**WEST RIDGE** RESOURCES, INC.

Re: NOV Abatement N02-49-1-1
West Ridge Mine
C/007/041-AM02A
Carbon County, Utah

Enclosed is the information requested in the T/A dated April 8, 2002. All revised pages should be inserted in Appendix 7-4. A C/C₂ Form is also enclosed.

This submittal is based on results of our meeting and subsequent conversation with Mr. Greg Galecki. The revisions address all concerns in the T/A, including the request to use the 10 year - 24 hour event for ditch design.

FIGURE 3

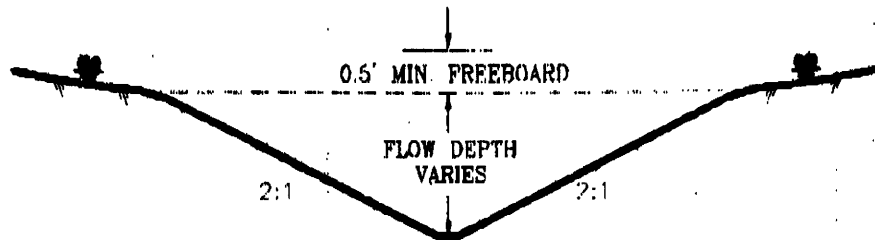
All ditches are designed to carry the expected runoff from a 10 year - 24 hour event with a minimum freeboard of 0.5' (See Figures 3 and 4). The 0.5' freeboard represents a minimum of 20% of the flow depth in all disturbed area ditches.

Ditches which exhibit expected flow velocities of 6 fps or greater based on the 10 year - 24 hour runoff, will be lined with rip-rap or concrete or constructed on bedrock. Typical cross-sections, flow depths and areas for all lined and unlined ditches are shown on Figures 3 and 4 of this report.

UNLINED DITCH		
DITCH	FLOW DEPTH	FLOW AREA (F.T. ²)
UD-Z	0.42	0.35
UD-15	0.59	0.71
DD-1	0.77	1.18
DD-2	1.17	2.75
DD-3	0.71	1.02
DD-4A	0.53	0.56
DD-5	0.74	1.09
DD-8	0.42	0.36
DD-9	0.58	0.66
DD-10	1.02	2.08
DD-11	1.65	5.46
DD-12	1.11	2.47
DD-13	0.41	0.34

Note: Flows based on a 10 year - 24 hour event.

FIGURE 4

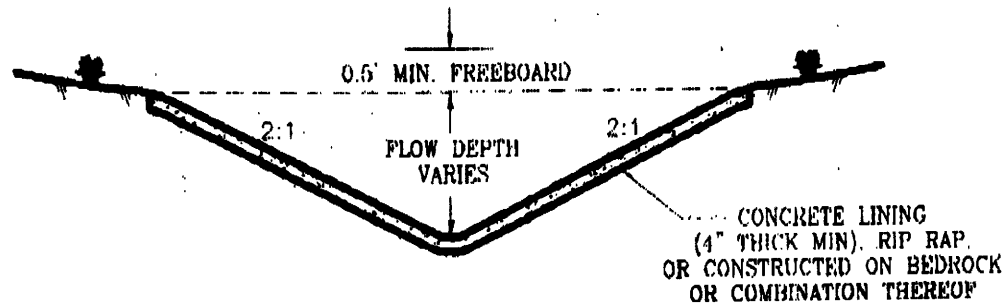
It should be noted that ditch DD-1 has a calculated flow velocity of 6.02 fps. Based on consultation with the Division, this ditch will not be lined unless it exhibits erosion in the future. Three additional ditches have calculated flows in excess of 6 fps. These are ditches DD-4, D-6 and DD-8A. DD-6 is constructed on bedrock, has been in place for 3 years, and shows no sign of eroding into the bedrock. Although the bedrock is in the ditch bottom, there are no plans to further line the ditch since erosion is not occurring. DD-8A has been rip-rapped in accordance with the plan. DD-4 will also be lined according to the plan.

LINED DITCH		
DITCH	FLOW DEPTH	FLOW AREA (FT. ²)
DD-4	1.15	2.86
DD-6	0.90	1.60
DD-8A	1.19	2.84

Note: Flows based on a 10 year - 24 hour event.
